Serial: RNP-RA/15-0016  
APR 24 2016

H. B. ROBINSON STEAM ELECTRIC PLANT, UNIT NO. 2  
DOCKET NO. 50-261 / RENEWED LICENSE NO. DPR-23

**APPLICATION FOR TECHNICAL SPECIFICATION CHANGE TO ADOPT TECHNICAL SPECIFICATIONS TASK FORCE (TSTF)-339, RELOCATE TS PARAMETERS TO THE COLR CONSISTENT WITH WCAP-14483, REVISION 2**

Figure 2.1.1-1 (page 1 of 1)  
Reactor Core Safety Limits

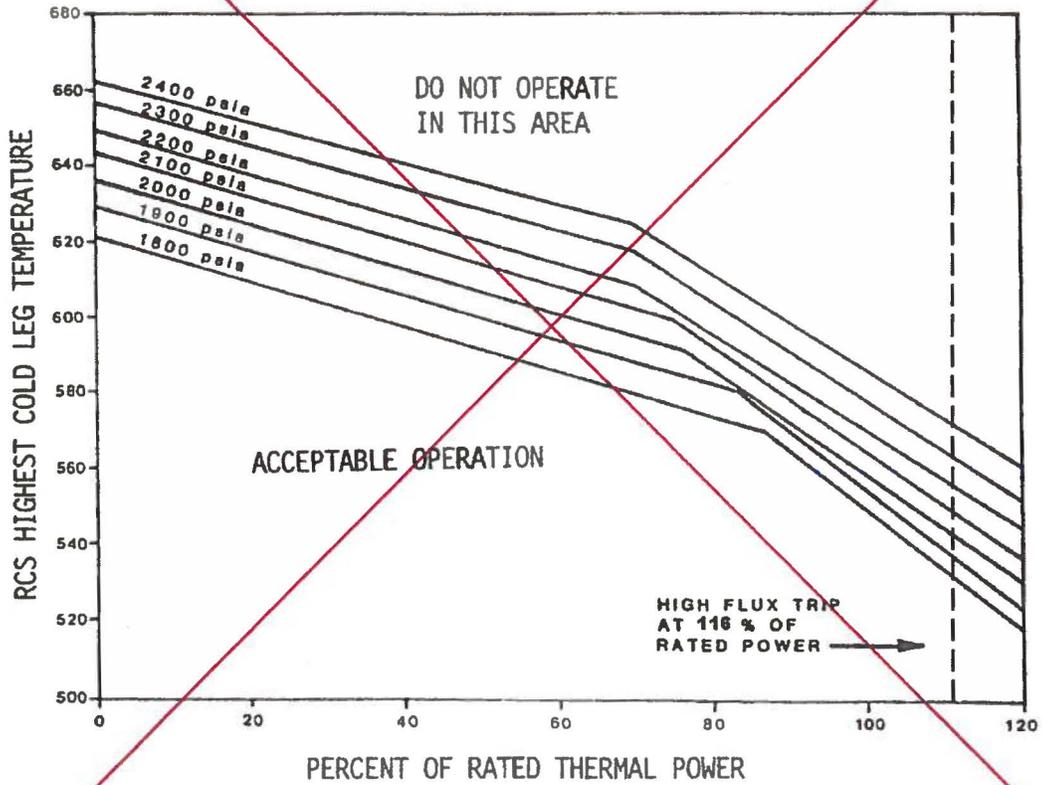
The proposed amendment would relocate TS Figure 2.1.1-1, "Reactor Core Safety Limits," to the COLR, replacing it with more specific requirements regarding the safety limits (i.e. fuel DNB design basis and the fuel centerline melt design basis) conforming with WCAP-14483-A. As discussed in the Safety Evaluation Reports to Westinghouse Topical Report, WCAP-14483-A, it is necessary to relocate TS Figure 2.1.1-1 to the COLR since cycle-dependent changes to parameters upon which TS Figure 2.1.1-1 is based would require a license amendment request to revise the figure.

In MODES 1 and 2, the combination of THERMAL POWER, Reactor Coolant System (RCS) highest cold leg temperature, and pressurizer pressure shall not exceed the SLs specified in Figure 2.1.1.1. ← Add INSERT # 1 here

DELETED  
Figure 2.1.1-1

the COLR; and the following SLs shall not be exceeded:

2.1.1.1 The departure from nucleate boiling ratio (DNBR) shall be maintained  $\geq 1.141$  for the HTP correlation and  $\geq 1.17$  for the XNB correlation.

2.1.1.2 The peak fuel centerline temperature shall be maintained  $< [(2790 - 17.9 \times P - 3.2 \times B) \times 1.8 + 32]$  °F where P is the maximum weight percent of Gadolinia (%) and B is the maximum pin burnup (GWD/MTU).
